**Reply to interactive comment on “Role of rainwater induced subsurface flow in water-level dynamics and thermoerosion of shallow thermokarst ponds on the Northeastern Qinghai–Tibet Plateau” by X. Pan et al.**

*Received from anonymous Referee #2*

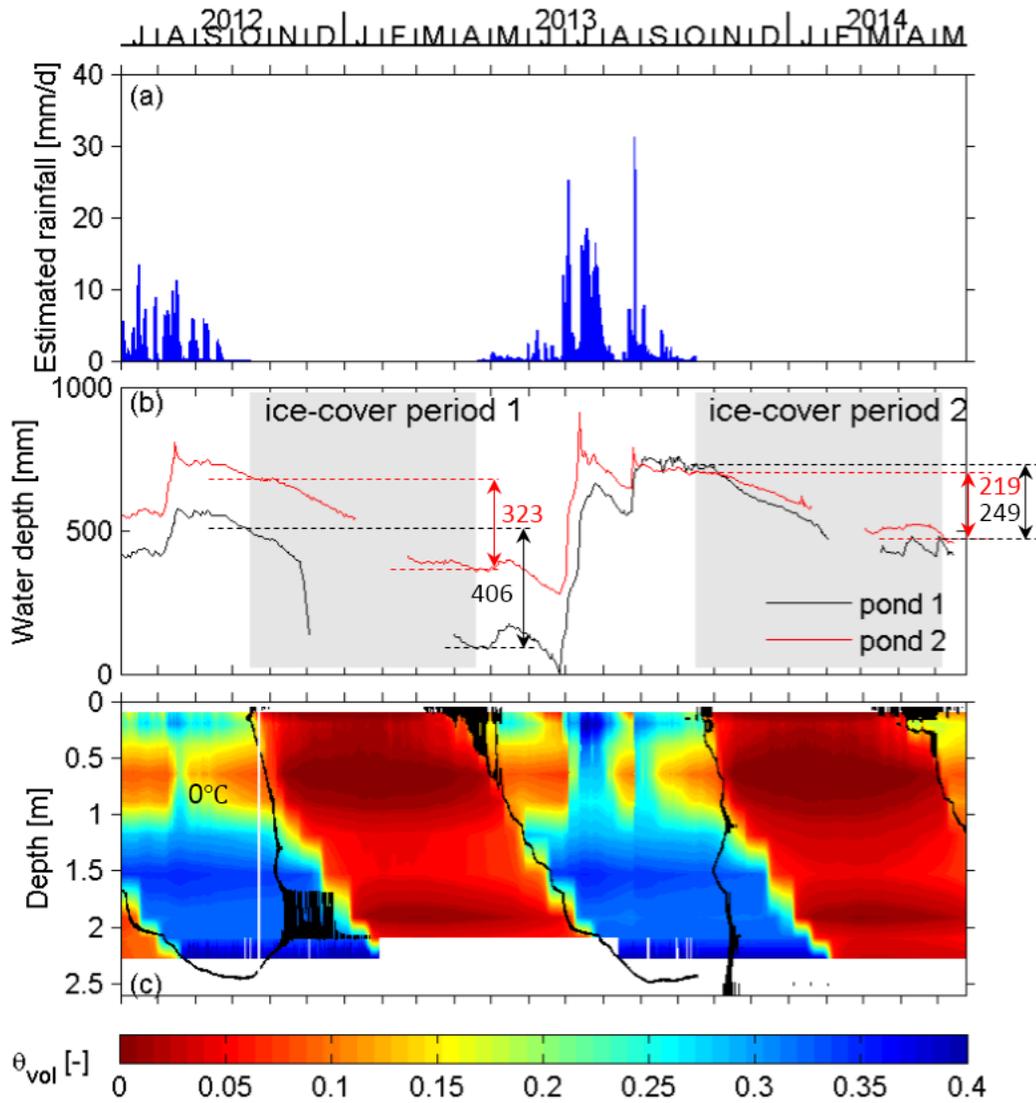
(9) *“The graphical quality of the figures is not always good and explicit (e.g. fig. 3) and the figure caption is not detailed enough to interpret/understand the figures.”*

New data were added for the blank area in the Fig 3 (Fig. 5 in the revised text). Figure captions were revised.
